Cilyrychen Quarry - IDO Stage II Registration

Analysis of Tarmac's Application and Technical Statements

**Dinefwr Green Group/Friends of the Earth and the
Campaign for the Protection of the Gwenlais Valley**

June 1997

Geological plans

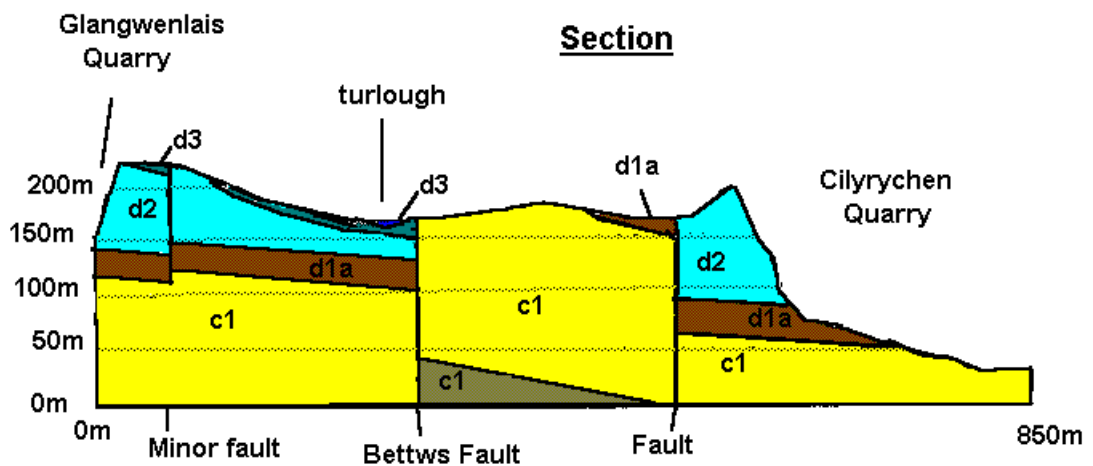
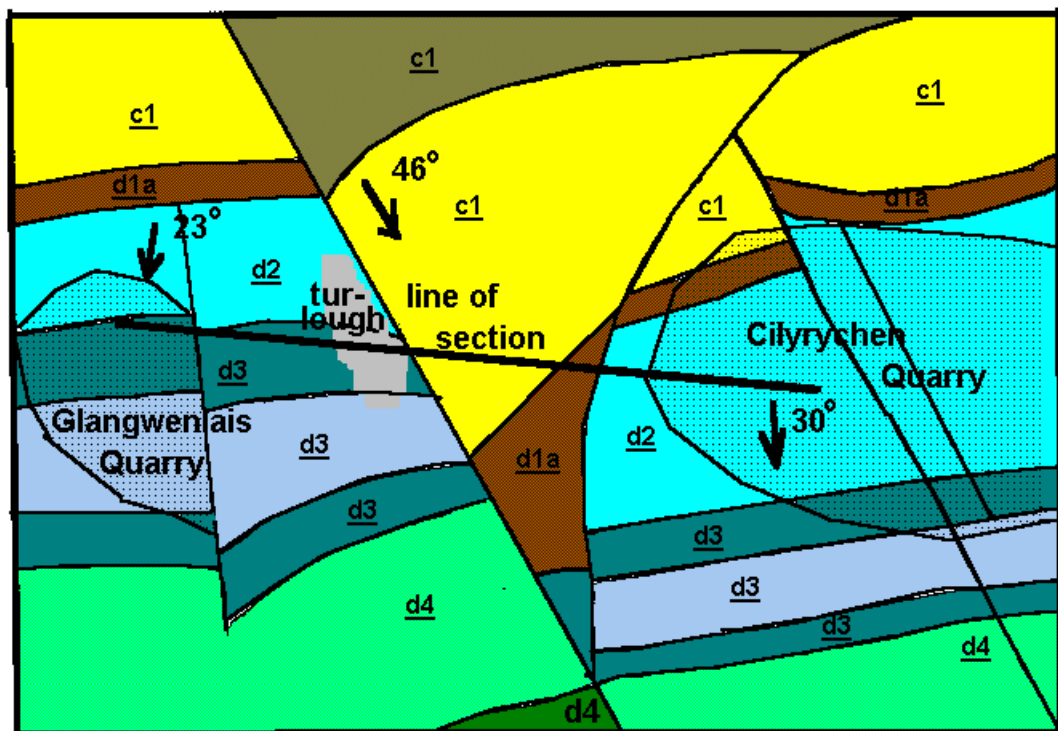
The two diagrams on the following page show a simplified representation of the surface geology taken from the British Geological Survey map. From this a simplified representation of a section between Cilyrychen Quarry and the turlough has been constructed. If the unconformity between the sandstone strata and the limestone strata is highly permeable it would represent a significant conduit for water movement from the west sub-catchment to the east sub-catchment, as identified in the Wimpey report.

The Geological Survey map identifies the limestone/sandstone junction as comprising various 'pebble beds'. The grey grits/plateau beds can be found a few miles to the east and represent the deposition of pebbly material contemporaneous with the deposit of the limestones. The 'pebbly beds' which occur in this area however represent material which formed part of the original erosion surface of the sandstones. From the scaled stratigraphic column the thickness of this strata varies from 0 to 120 metres. From calculations made using the apparent width of the strata at the surface, and the angle of dip, the thickness of the strata in this area would be around 10m to 20m. This would represent a significant conduit for water movement.

The plan shows a simplified representation of the solid geology between the Cilyrychen and Glangwenlais Quarries. The plan shows the geology at the surface, and so the boundaries are affected by topography. The section below - the line of which is given on the plan - runs between the two quarries, and directly beneath the turlough. The vertical scale has not been exaggerated on this plot. The limited availability of information also means that the section is only notional - there are no other sources of data to confirm the dip of the strata at depth, or the maintenance of strata thickness in the upthrust block between the eastern and western ends of the section.

To conclude this section, it is clear that there is insufficient evidence to prove or disprove a link between the east and west sub-catchment. This would need to be established by direct observation using boreholes to monitor the relative changes in water levels across the upthrust block. If larger void were identified as a possible cause
